# PRODUCT CHANGE NOTIFICATION

## Select Bourns® Model SRU1028 Series Shielded SMD Power Inductors

### Change to Inductor Shield Design

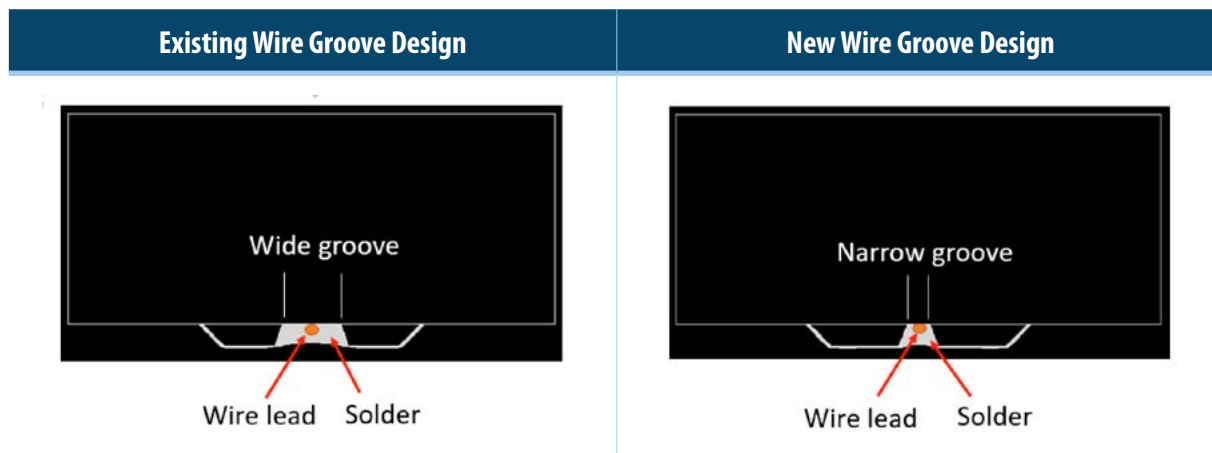
Riverside, California – July 23, 2021 – Effective January 22, 2022, Bourns will change the inductor ferrite shield design for select [Model SRU1028 Series](#) Shielded SMD Power Inductors. The wire groove of the modified ferrite shield will be narrowed which will result in a better fitting for the wire lead.

The form of the inductor will change because of the narrower wire groove. The fit and function of the inductor will remain the same. The quality and reliability of the component should be improved.
